DELEGATED OFFICER REPORT

WOKINGHAM
BOROUGH COUNCIL

Application Number:	251339
Site Address:	14 Nightingale Road, Woodley, Wokingham, RG5 3LS
Expiry Date:	15 August 2025
Site Visit Date:	28 July 2025
Proposal: Householder application for the proposed two storey side/rear extension, partial garage conversion and changes to fenestration.

Figure 1 Vertical 45-degree angle test and approximate midpoint of nearest habitable window shown yellow

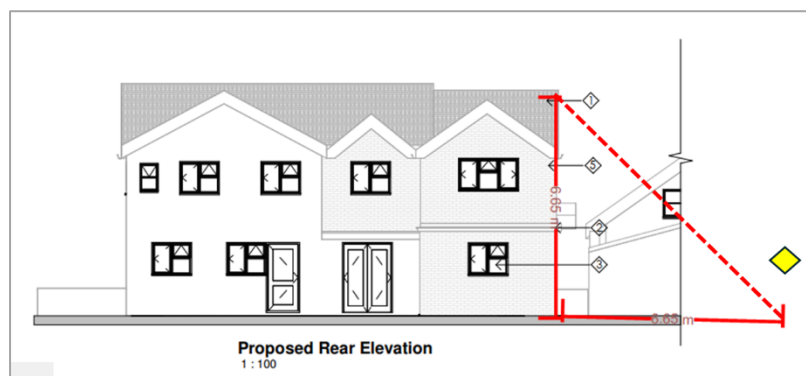
Loss of Light: The rear gardens of adjacent neighbours are east facing and receive morning sunlight throughout the year. The 45-degree angle test is advocated within the British Research Establishment's (BRE) publication Site Layout Planning for Daylight and Sunlight: a guide to good practice, to assess impact on daylight and sunlight levels to neighbours potentially impacted upon by adjacent developments. As can be seen in Figures 1 and 2, both the horizontal and vertical test are complied with. Furthermore, near to the side boundary, the glazed lean at no. 12 does not serve a habitable room and the ground floor room forward of this has its main outlook from a front facing window. Therefore, the neighbour at no.12 Nightingale Road would not be significantly impacted by additional loss of light.
